PUBLIC INTEREST REVIEW FOR GROUNDWATER APPLICATIONS

TO: Water Rights Section Date 02/25/2021
 FROM: Groundwater Section Phillip I. Marcy
 Reviewer's Name
 SUBJECT: Application G- 19053 Supersedes review of _____
 Date of Review(s)

A. GENERAL INFORMATION: Applicant's Name: Dale Eisiminger County: Union

Water-Level Trends in Nearby Wells

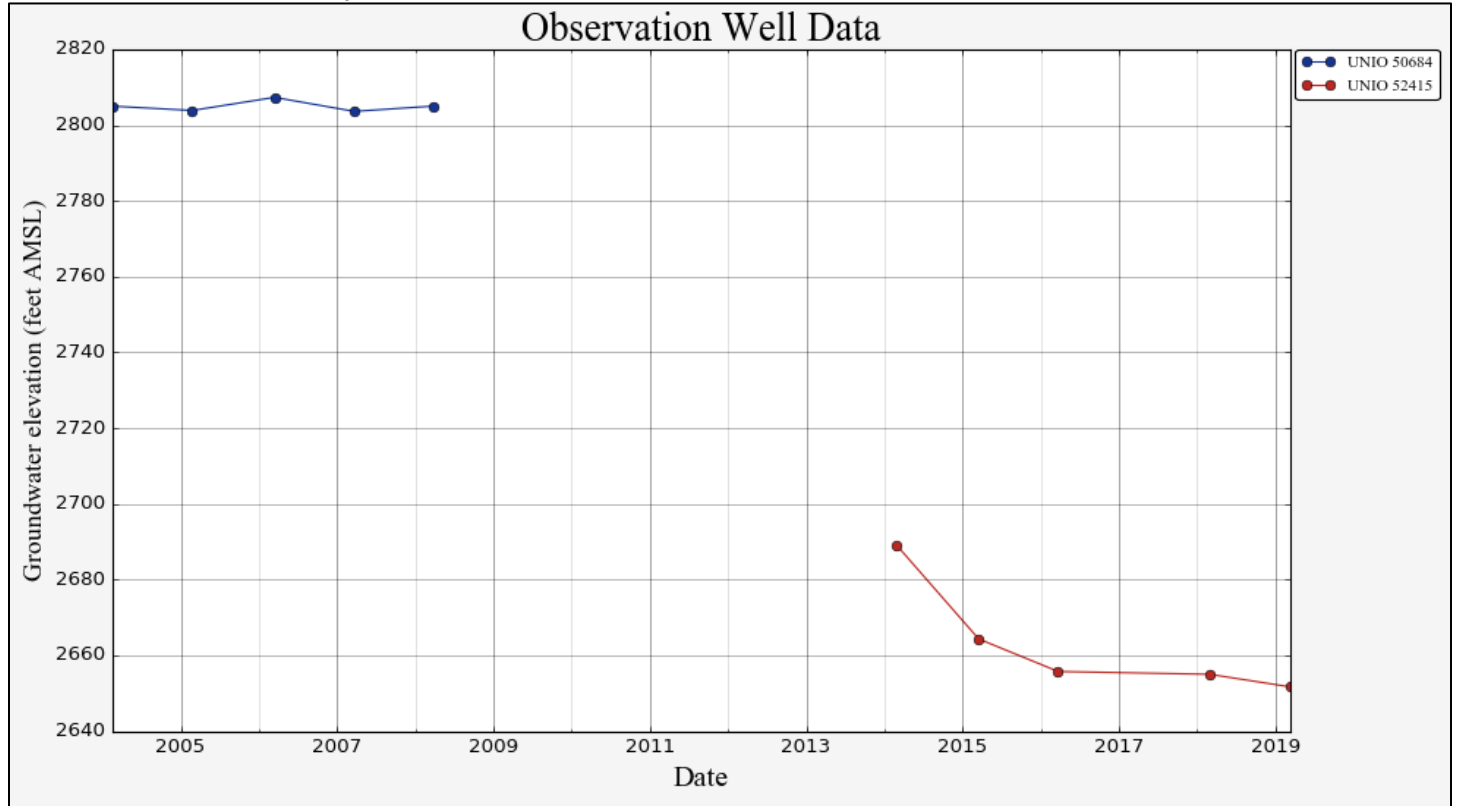
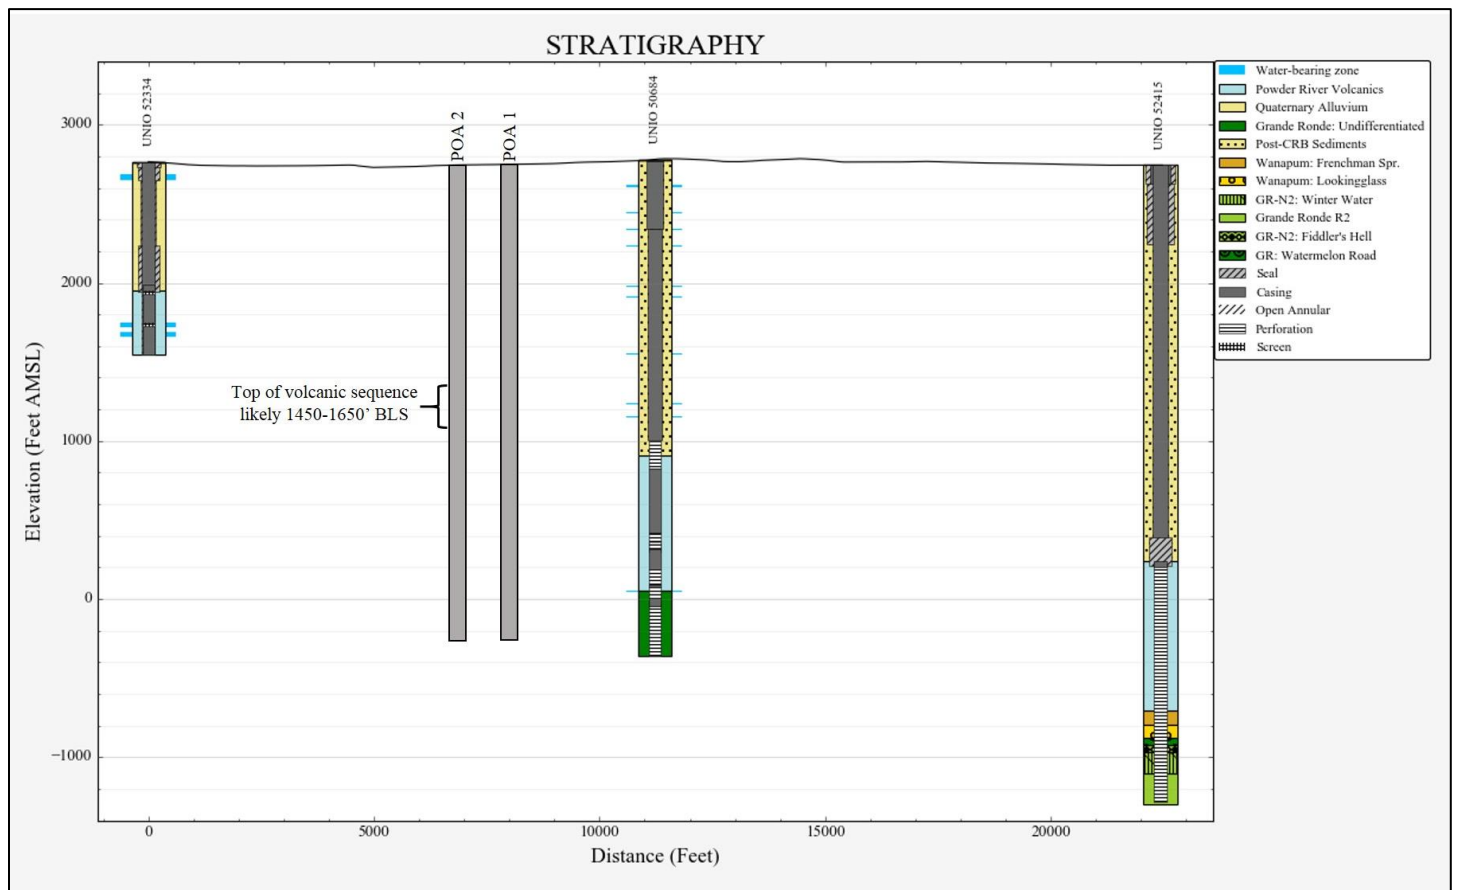
Water level data for wells completed into the volcanic sequence underlying alluvium in this area are severely limited. This limitation renders conclusions concerning capacity of the resource and well-to-well interference unreliable. From the above data, for example, it cannot be concluded that the two wells have similar or dissimilar trends.

Lithologic information from driller's well reports suggest that depth to the top of the volcanic sequence increases with distance from the valley margin to the west. There are not adequate data at this time to indicate whether this trend is due to offset by concealed faults between these sites or represents the dip slope of these units.
